# City of Alexandria, Virginia

## MEMORANDUM

**SUBJECT:** CONCEPT REVIEW OF 1101 NORTH WASHINGTON STREET  
(BEST WESTERN OLD COLONY INN)  
BAR CASE # 2015-0156

EXTERIOR  
ELEVATIONS

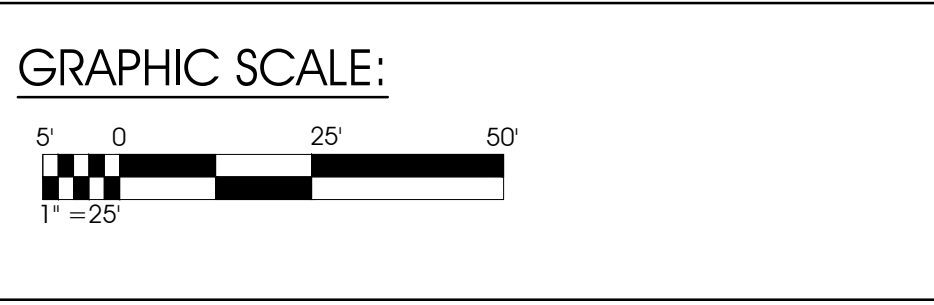
- *Refine the first floor windows at the restaurant section on the southern end.* Because this building is not intended to be symmetrical, and to enhance the different function of this end of the building, staff recommends removing the over-sized multi-paned windows on the ground floor in favor of arched windows, such as shown in some of the precedent photos of similar hotels. This will also complement the one-story arcades adjacent to the porte-cochère. This change should be applied to all three elevations of the southern end.

- *Revise aspects of the at-grade garage.* Study the elimination of the parking garage entrance on the Washington Street elevation. While this is an existing condition, it would improve the overall composition to remove this vehicular entry since there is also an entry on the rear elevation and it only provides access to a few parking spaces. Additionally, the drawings show non-descript vented openings adjacent to the garage area

on the front elevation. While the need to properly ventilate this garage space is well understood, these elements should be intentionally designed, reading as doors or windows with stylistically appropriate metalwork.

- *Lighten the parapet on the flat-roofed portions.* The variation in roof height is important to differentiate sections of this long building and to comply with the Washington Street Standards (more follows) but the use of recessed brick panels at the parapet is visually heavy. Staff recommends pursuing a more traditional, open balustrade railing in a light color at this location, perhaps that relates to the balustrade atop the porte-cochère.

- *Enhance the cornice between the third and fourth stories.* A strong and well-detailed cornice defines the Colonial Revival style no matter how it is interpreted. The current proposal shows a brick entablature with a narrow trim at the top of the cornice. Because of the set back from Washington Street, it is quite likely that this element will not read as intended and staff recommends strengthening this element by incorporating a visually substantial entablature in this same location that is all white. The entablature could be either metal or a high-quality synthetic material. This will also reduce the apparent mass and height of the hyphen/running walls by visually transforming the fourth story above into a classical attic story.

- *Refine window proportions and arrangement.* The windows above the porte-cochère need further refinement, particularly the arrangement of the two smaller windows adjacent to a regular window. This is also an opportunity to do a feature window, typical of the Colonial Revival style. As the design evolves, the applicant should continue to refine the fenestration.

- *Strengthen the rear elevation.* While this elevation should not possess the same prominence as the front, the proposed entry portico seems to have a diminutive scale. One option would be to consider adding a flanking arcade, similar to the front elevation, for the central portion. Additionally, the proposed loading door appears incongruous. It should be better designed and integrated into the overall composition.

STREETSCAPES

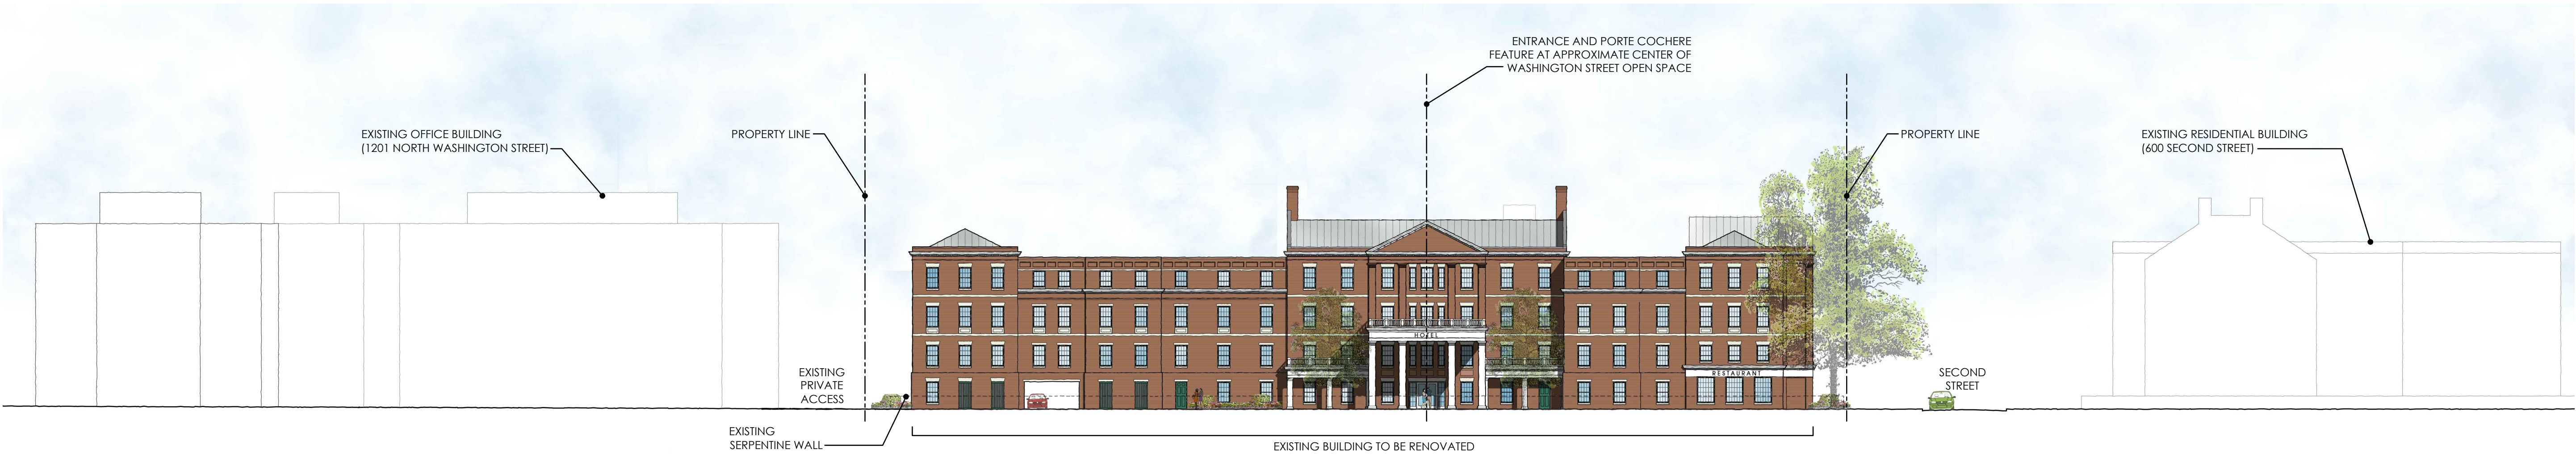
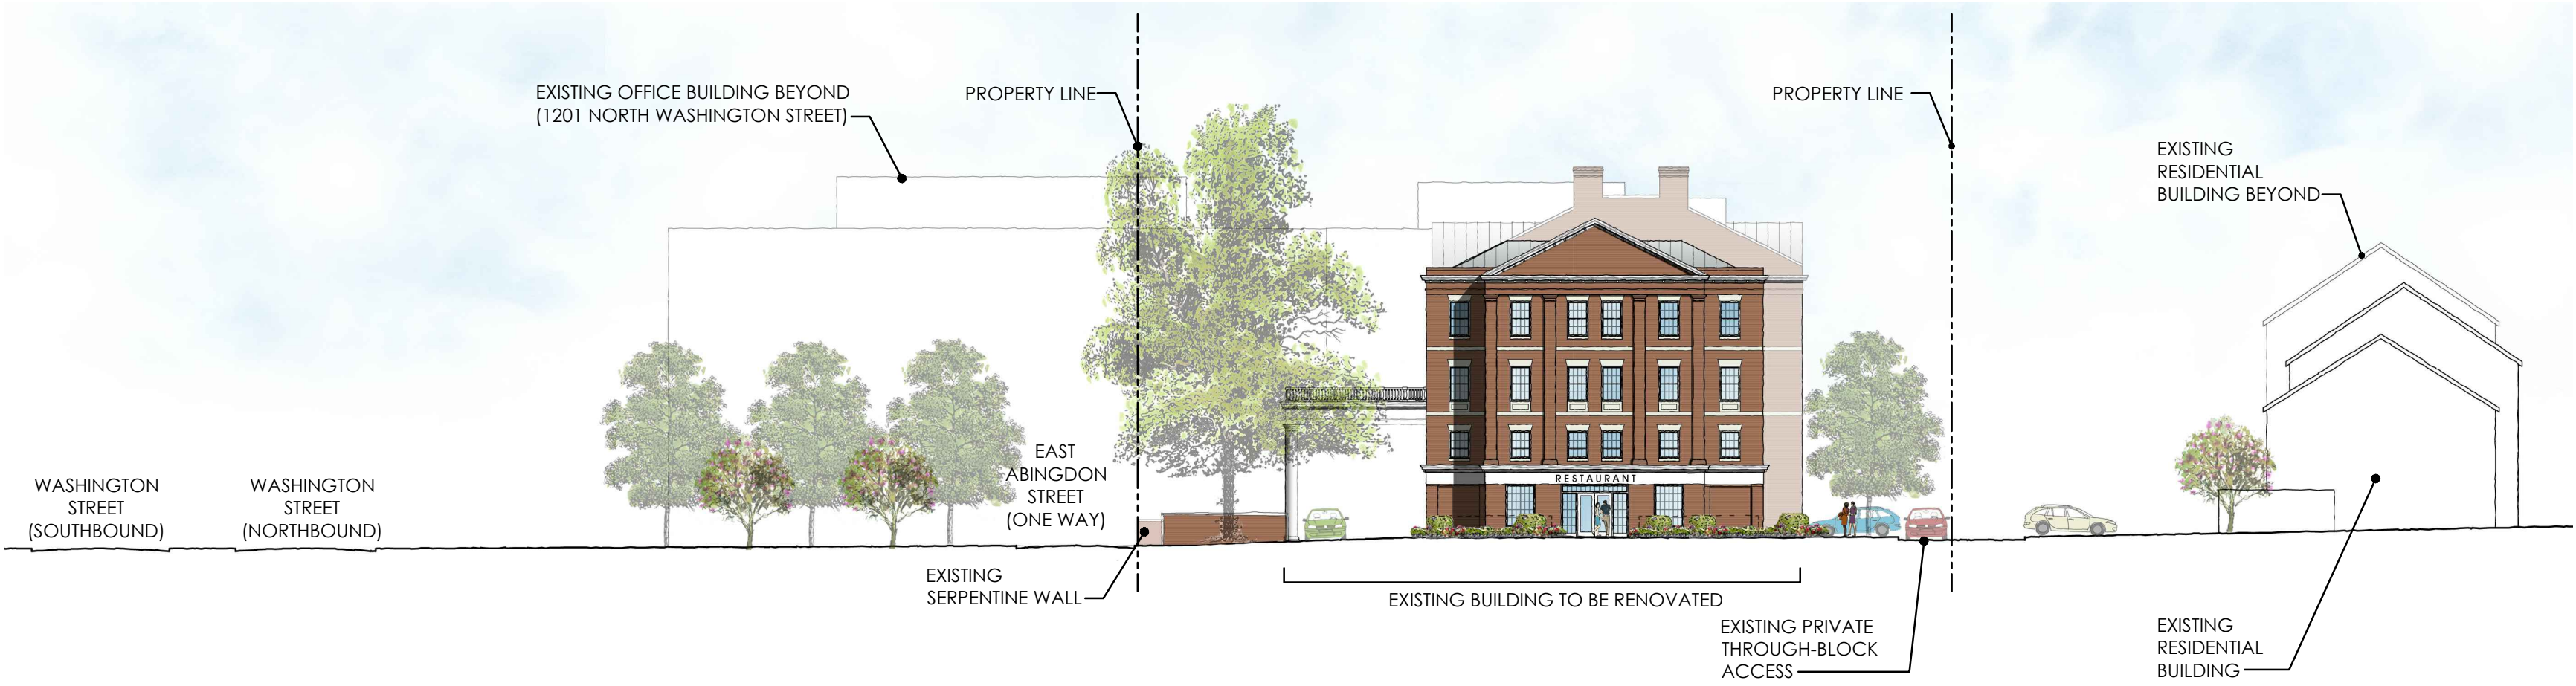
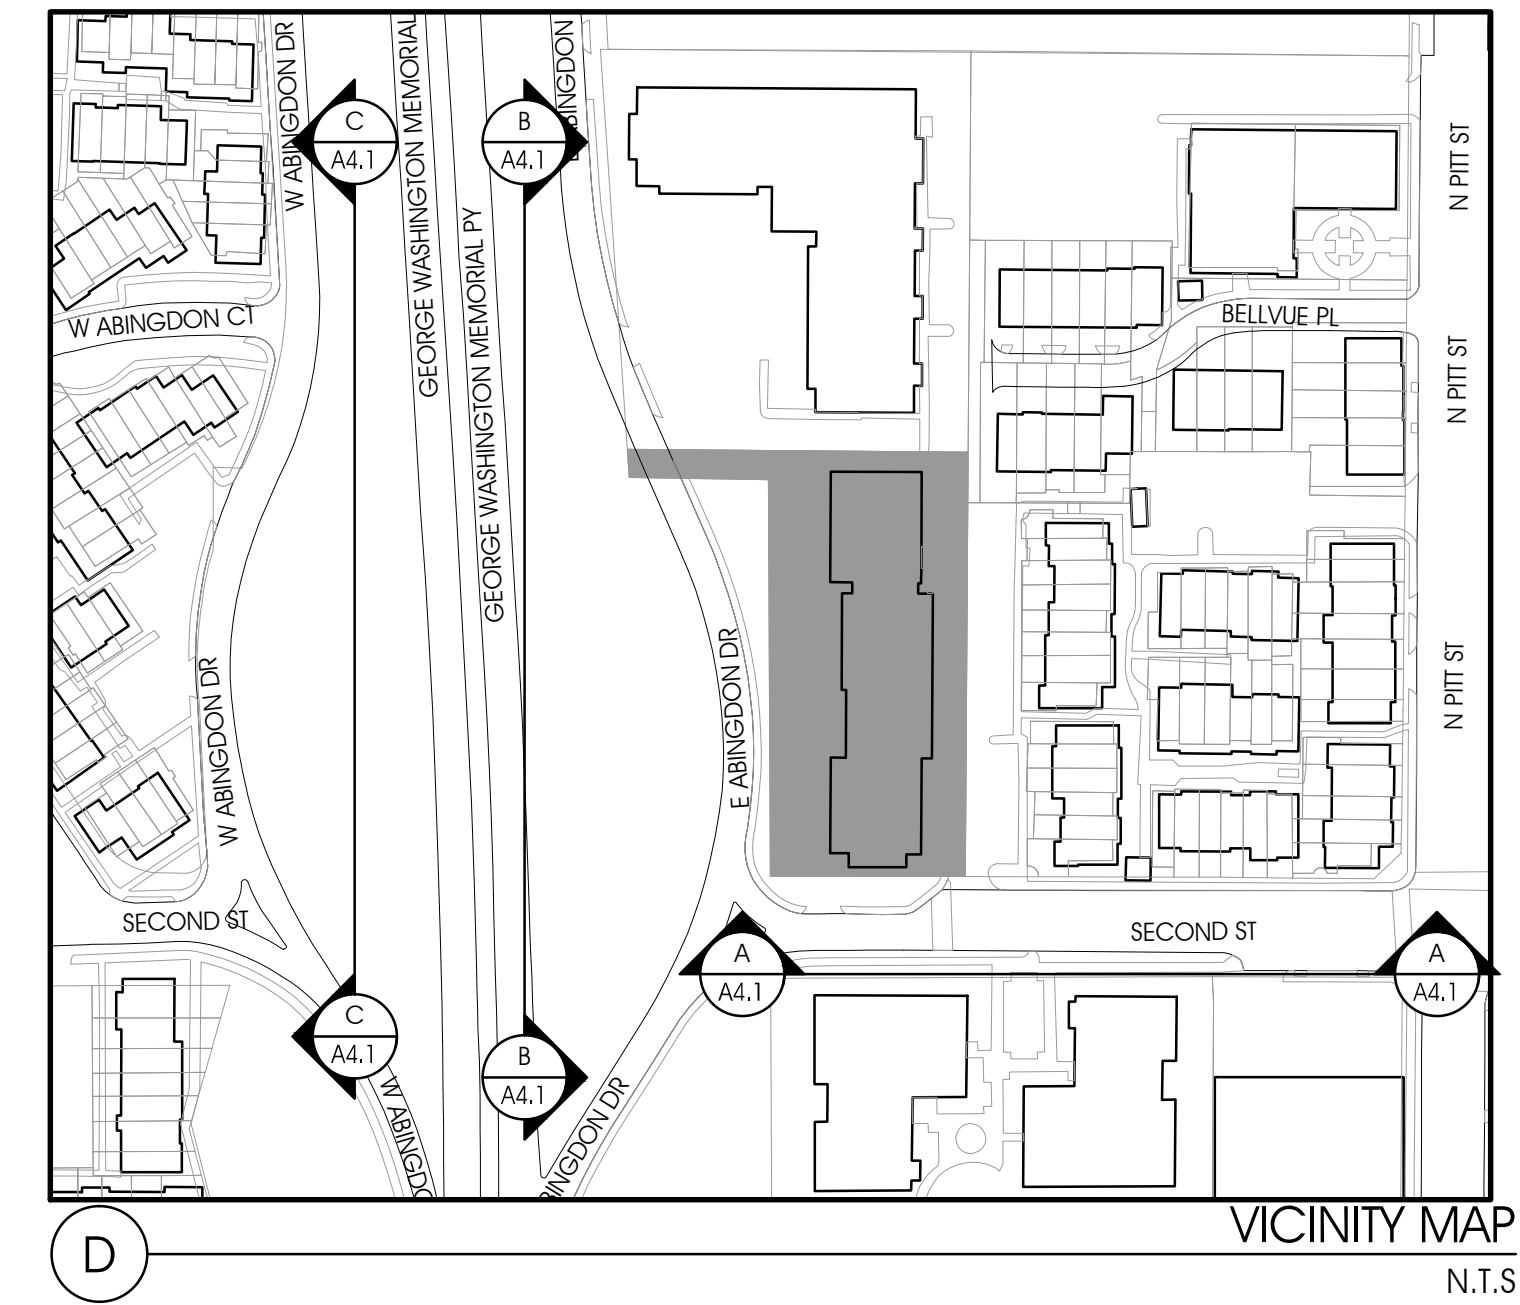
**The applicant has included digital massing models of the surrounding blocks illustrating that the proposed massing is consistent with the context of this area of North Washington Street.**
